# National Committee on Uniform Traffic Control Devices

**Attachment No.: 9  
Item No.: 19B-SIG-03**

## NCUTCD Approved Changes to the Manual on Uniform Traffic Control Devices

**TECHNICAL COMMITTEE:** Signals Technical Committee  
**ITEM NUMBER:** 19B-SIG-03  
**TOPIC:** Pedestrian Pushbutton Locations  
**ORIGIN OF REQUEST:** Signals Technical Committee  
**AFFECTED SECTIONS  
OF MUTCD:** 4I.06 Pedestrian Detectors

Figure 4I-X. Pushbutton Location Area

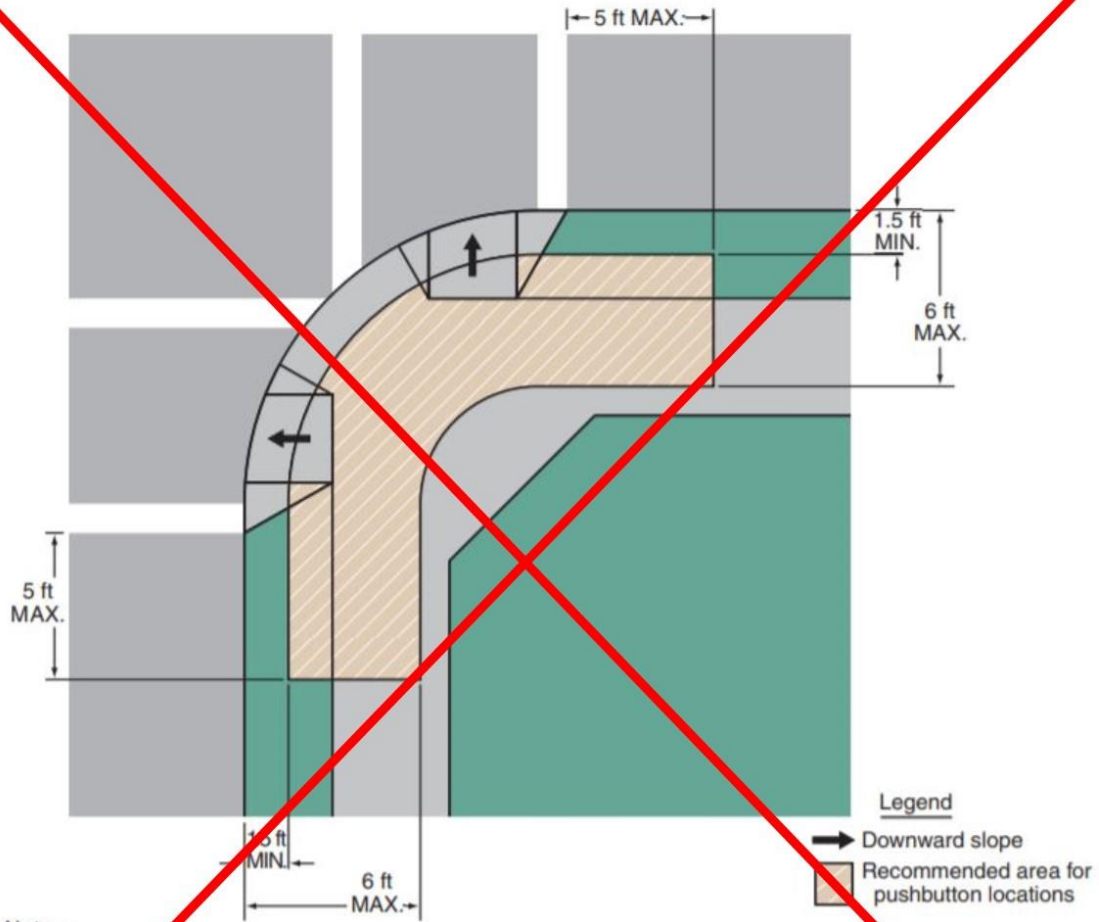
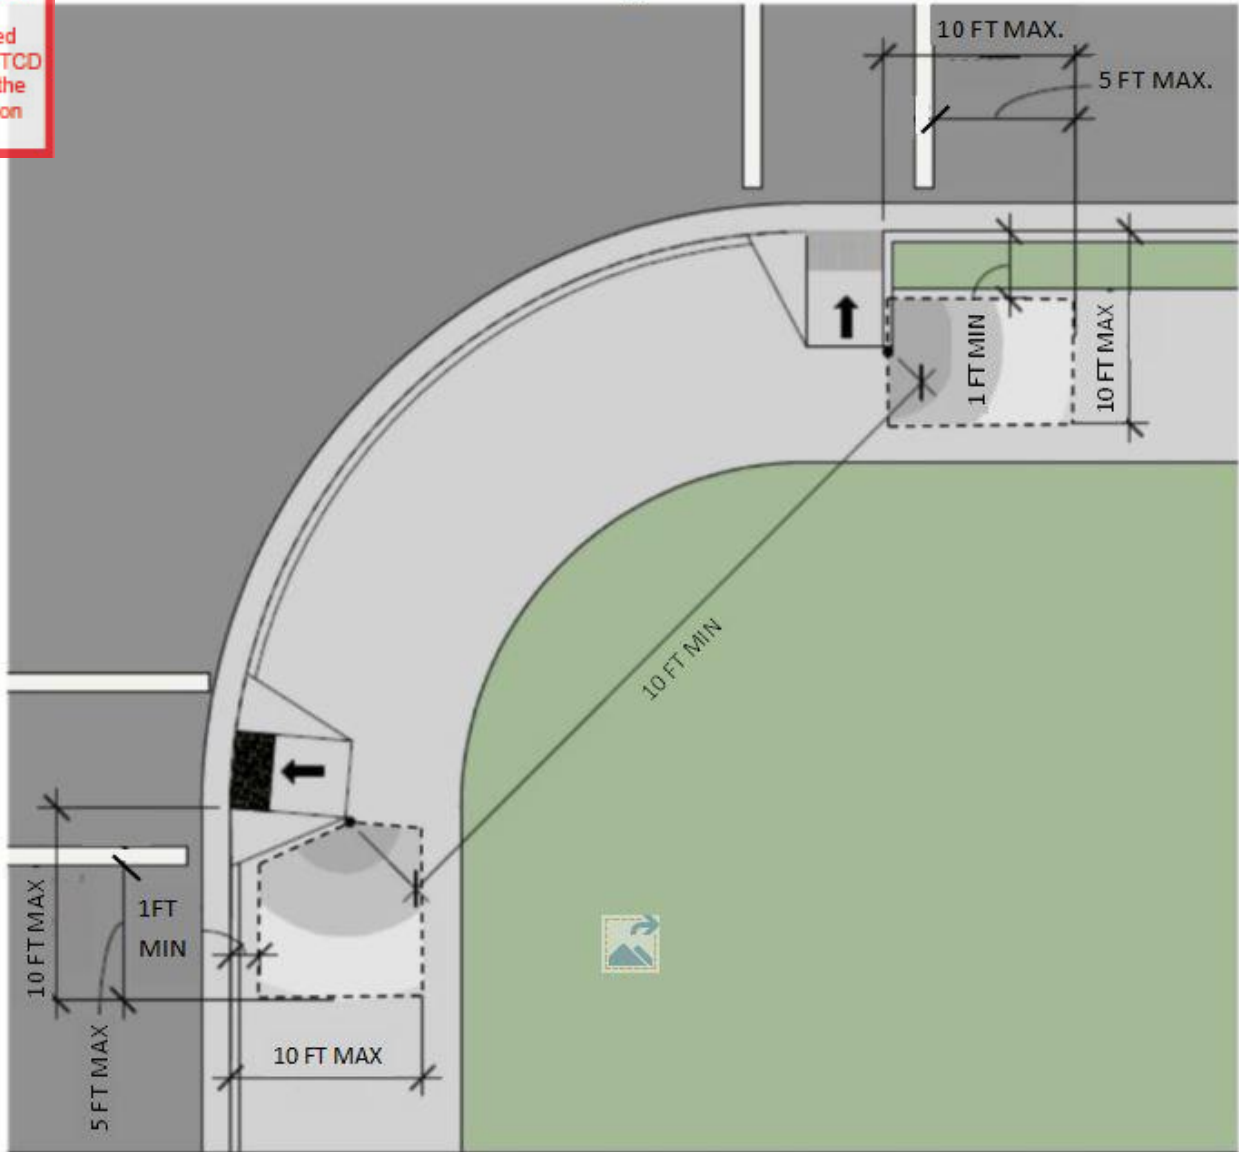
Provisions for pedestrian detectors were reviewed with respect to updating guidelines to better reflect accessibility needs. There are ideal locations for the placement of pedestrian detectors to serve accessibility needs. However, field conditions do not always allow for the optimal placement. Accordingly, revised language is proposed which would clarify optimal placement of pedestrian detectors while allowing for defined flexibility and latitude, where necessary, to accommodate unique conditions for a given location. These revisions are shown in a revised Figure 4I-X, formerly Figure 4E-3.

154 [Figure 4E-3 to be replaced with Figure 4I-X]

1. [No greater than 5 feet from the outside edge of the marked crosswalk farthest from the intersection.](#)
2. [Not farther from the crosswalk than the stop line, if present.](#)
3. Any maximum (MAX) or minimum (MIN) dimensions shown are based on Guidance Statements.
4. Two pedestrian pushbuttons on a corner should be separated by [a minimum of 10 feet](#). The 10-foot dimension shown in this figure is in reference to the [placement of the pushbuttons within their respective](#) areas.
5. Figure [4I-4](#) ~~4E-4~~ shows typical pushbutton locations.
